UPPER TRISHULI-1 HEP (216MW)

Client	Nepal Water and Energy Development Company Private Limited		
Owner's Engineer	Tractebel Engineering GmbH / Jade Consult		
REVIEW NOTE			
Contractor	Doosan Enerbility		
Title of the Document	Excavation and Initial Support Drawings of Main Access Tunnel to Powerhouse		
Document No.	UT1-C-090-CVL-DG-64002	Revision	0B
Date of Documents	20.05.2022	Received Date	31.05.2022
Transmittal Form No.	UT1-HEP-DHI-D-0247		
Previous Review Date/Status	N/A	Prev. Review Note No.	N/A
Review Note No.	RN-0132	Present Review Date	05.06.2022
		Present Review Status	AN
A: Approved AN: Approved as Noted RR: Returned for Resubmission FI: For Information, only

Drawing No.: UT1-C-090-CVL-DG-64002 (sh. 1/6), version 0B

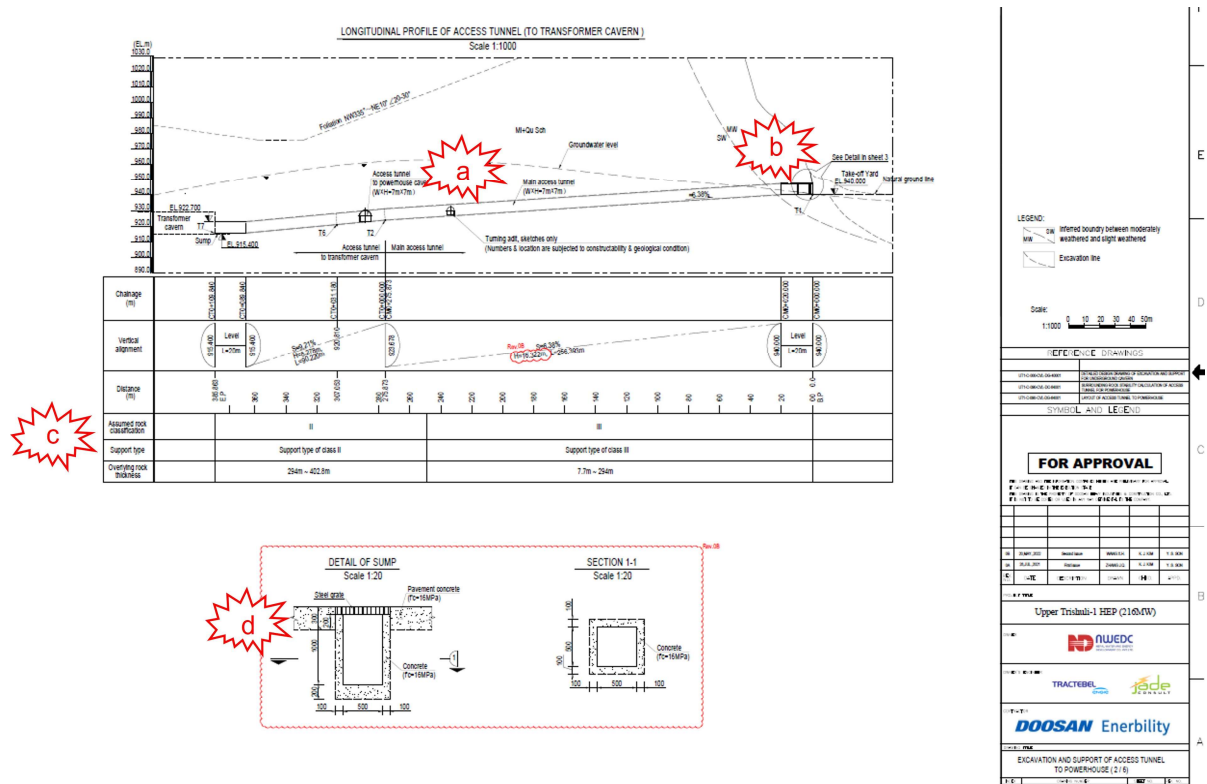
- Incorporate in the drawing the geological findings from the detailed investigation of discontinuities around the Powerhouse Complex. Provide one overall hemispherical plot and a small table with discontinuity details (Dip and Dip Direction, only).
- Turning bays not required. Tunnel is large enough for parallel/simultaneous mucking and muck loading.
- Delete Support Type row.
- Provide overburden thickness for the given chainages above.
- Item 13: Make clear reference to respective layout drawing and concrete drawing.

Drawing No.: UT1-C-090-CVL-DG-64002 (sh. 2/6), version 0B

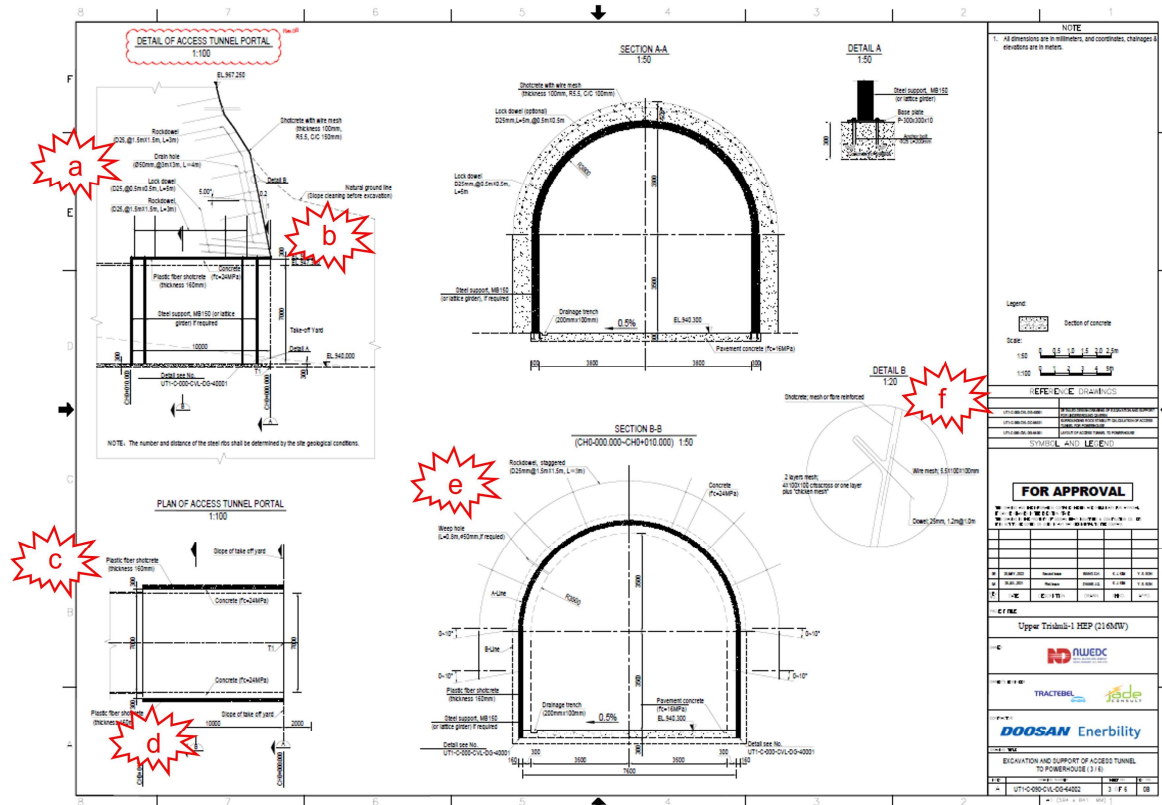
- Turning bays not required. Tunnel is large enough for parallel/simultaneous mucking and muck loading.
- Adjust slope topography to actual conditions.
- Delete Support Type row and provide overburden thickness for the given chainages above.
- Reconsider sumps sizes and locations. Indicate clearly the location of sumps. Consider actual requirements (= discharge into tunnel in rainy season). Consider also constructability.

Drawing No.: UT1-C-090-CVL-DG-64002 (sh. 3/6), version 0B

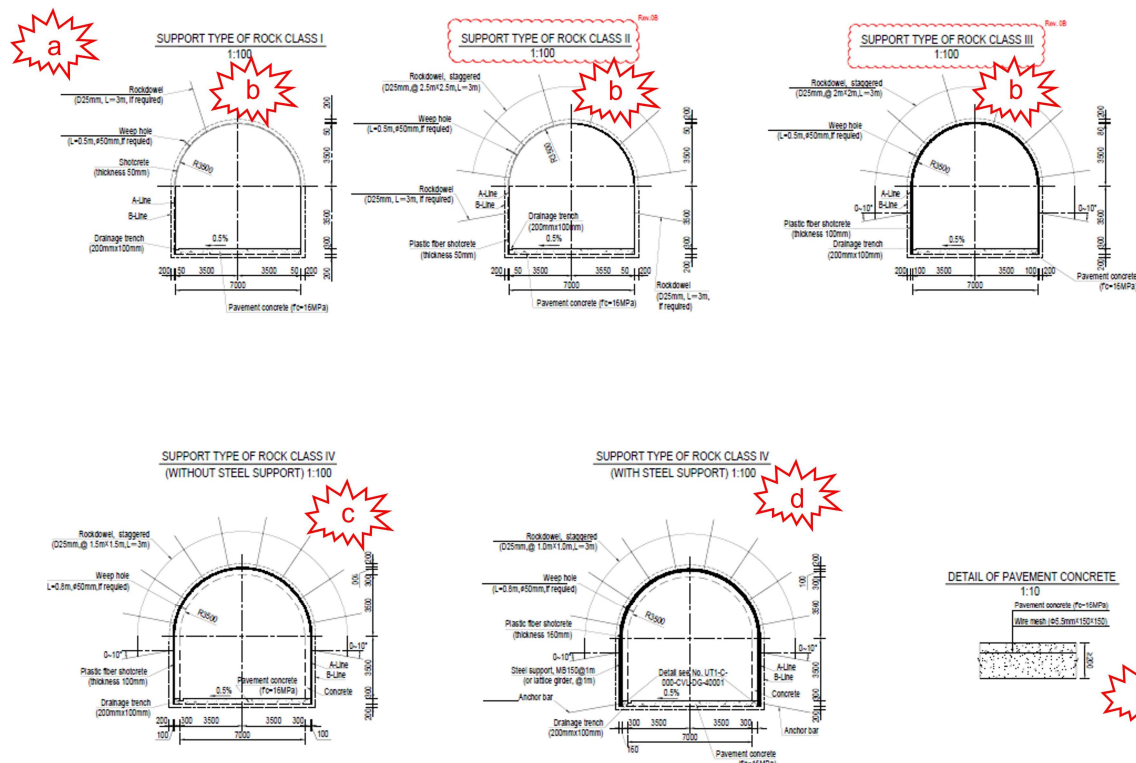
- Adjust slope geometry to as actual built conditions and indicate slope support accordingly.
- Adjust portal support to actual as built conditions. Indicate permanent concrete portal structure.
- Provide actual as built support for roof support.
- Provide longitudinal slope of concrete invert.
- Adjust roof and sidewall support to actual as built conditions.
- Adjust drainage ditch to actual as built conditions.

Drawing No.: UT1-C-090-CVL-DG-64002 (sh. 4/6), version 0B

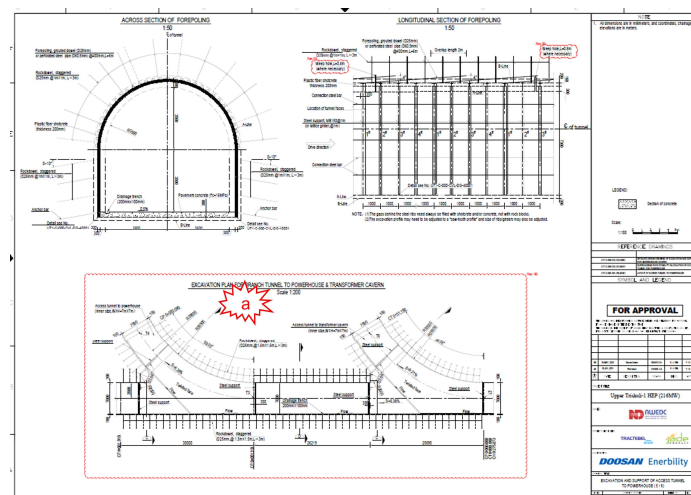
- Subdivide drawing for Class I, II, III and Class IV, V.
- Indicate roof bolts and pattern. Provide drawing of bolts or refer to respective approved drawing. **50 mm of shotcrete in Class II rock are certainly insufficient, particularly when considering that dowels in sidewalls are optional. 80 mm thick shotcrete over the whole perimeter is appropriate.**
- Indicate alternatively to concrete liner, shotcrete inner liner with respective strength and thickness.
- Same as (c).
- Reconsider reinforcement in concrete invert ref strength requirements.

Drawing No.: UT1-C-090-CVL-DG-64002 (sh. 5/6), version 0B

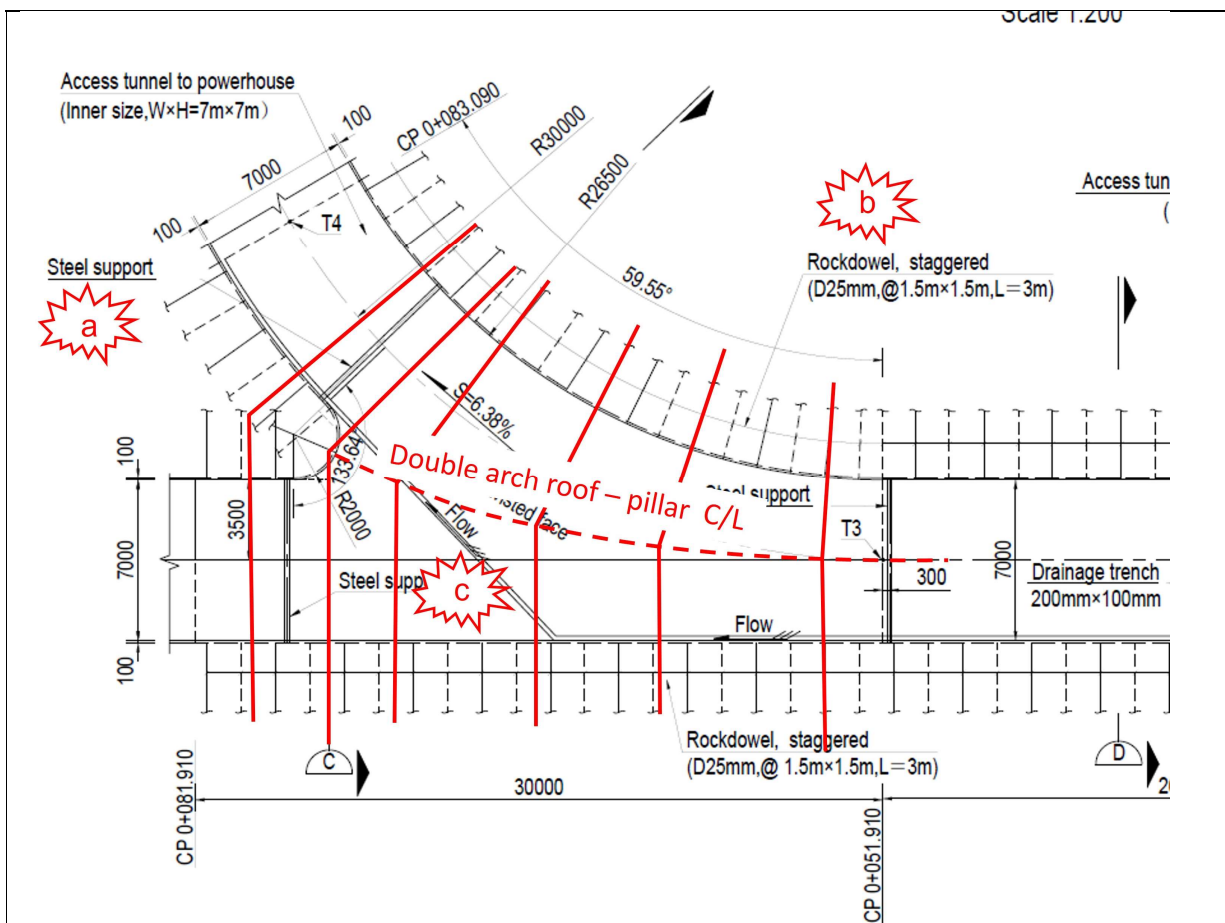
- Indicate steel support (ribs) as “as required”.
- Indicate support for Class III. The branches will presumably be opened in Class II rock. Q-values doubles as Joint Number J_n doubles in junctions. Therefore, use Class III support. Put in notes that it is assumed that the rock class is expected to be Class II, otherwise support needs to be adjusted.
- Provide a set of sections, cross sections similar as indicated above with Class III support, and a section along the “double arch roof-pillar centreline”, also with Class III support. Indicate additional support for the pillar in respective sections.

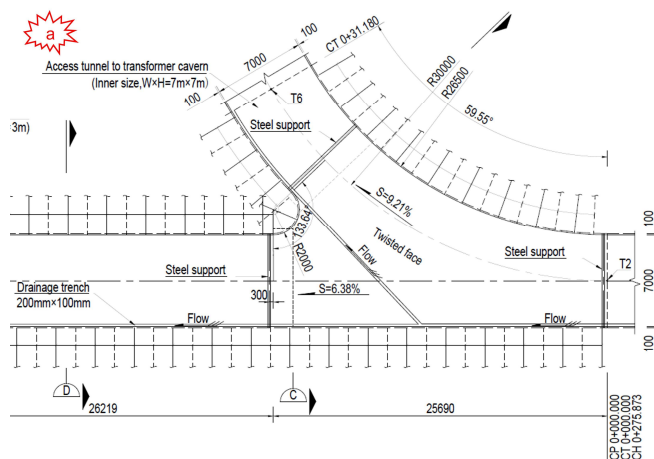
- (a) Modify drawing for branch to Transformer Hall as shown above for the branch to Powerhouse.

Drawing No.: UT1-C-090-CVL-DG-64002 (sh. 6/6), version 0B

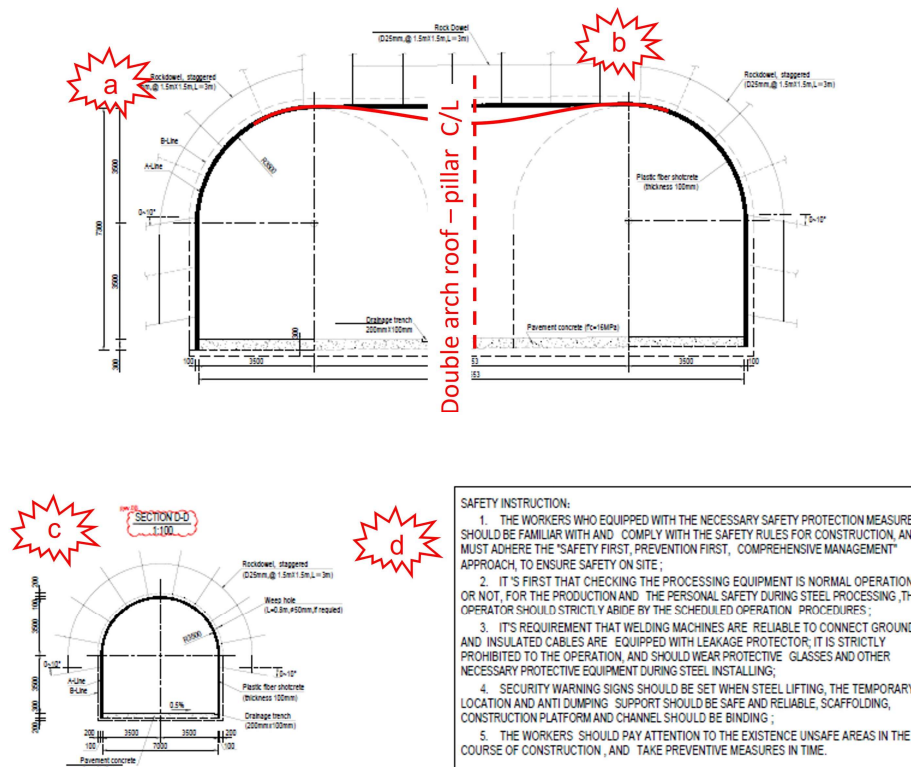
- (a) Adjust to correct section geometry.
- (b) Adjust to Class III support.
- (c) Delete typical tunnel section, as this already given for the individual support classes.
- (d) Delete safety instruction. Provide those in the Method Statement.
